Eclipse Sports (Pvt.) Ltd.

Latitude: [32.477965], longitude: [74.427812]
Date of inspection: 11-Mar-2026

Electrical Safety Inspection Report

Pakistan Accord Initial Safety Inspection Report

Figure 2.4 - Hot spot found on the yellow bus bar in PFI (power factor improvement) panel ground floor

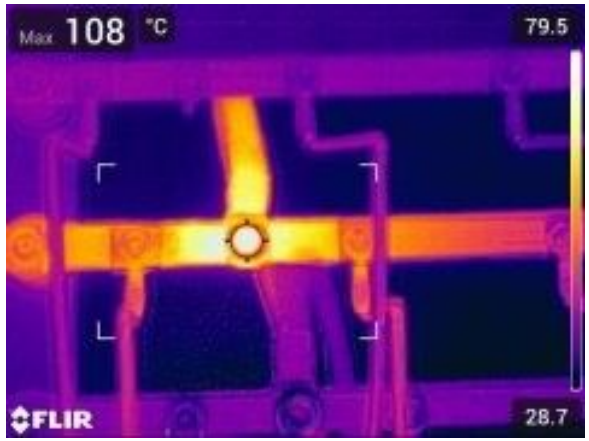
The categories of identified hot spots have been evaluated as per the ANSI NETA MTS 2019 standard, Table 100.18. Hot spots were observed, particularly at the following locations:

i. 108°C at the yellow bus bar in PFI (power factor improvement) panel on ground floor
ii. 103°C and 61°C on the cable connection of the main breaker in sublimation bed hall
iii. 89.3°C at the PCB board of the capacitor in PFI (power factor improvement) panel on ground floor
iv. 53.2°C on the red cable connection of main breaker of office distribution board on third floor

Timeline	Remediation Plan
Immediate CAP-0075711	Any circuits identified on site with temperatures exceeding 40°C above the ambient temperature, operating above 90°C or exhibiting visual signs of burning must be immediately isolated and taken out of service. These circuits should remain de-energized until a thorough review has been conducted and appropriate remedial actions have been implemented to resolve the underlying issues.
Medium Term CAP-0075712	During the inspection, several circuits were identified where the temperature was exceeding 20°C above ambient temperature. It is recommended that the factory conducts comprehensive thermographic surveys of all electrical panels to detect similar issues. Identified hot spots should be thoroughly reviewed to determine their underlying causes. Corrective actions must be taken to address and resolve these issues, ensuring safe and reliable operation of the electrical systems.

Figure 2.20 - Multiple connections found in electrical panel of stitching machines on third floor

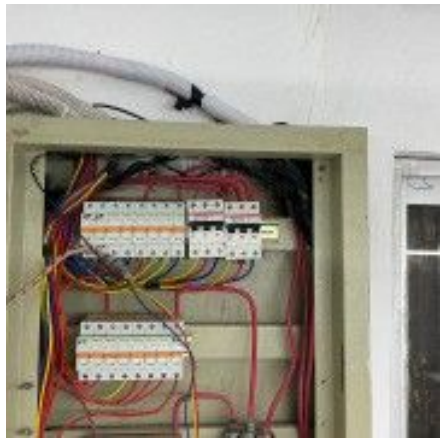
During our inspection, multilooping was observed in a number of electrical panels across the facility. This issue was specifically observed in the distribution board of packing, finishing, stitching, forceps assembling and main electrical panel on third floor.

In these cases, multiple circuits were being protected by a single circuit breaker.

Timeline	Remediation Plan
Medium Term CAP-0075742	The electrical installation throughout the facility shall be modified to ensure each circuit is protected by a dedicated circuit breaker of a suitable type and rating for each individual circuit in accordance with Section 430 of BS 7671 18th Edition + A2 (2022).
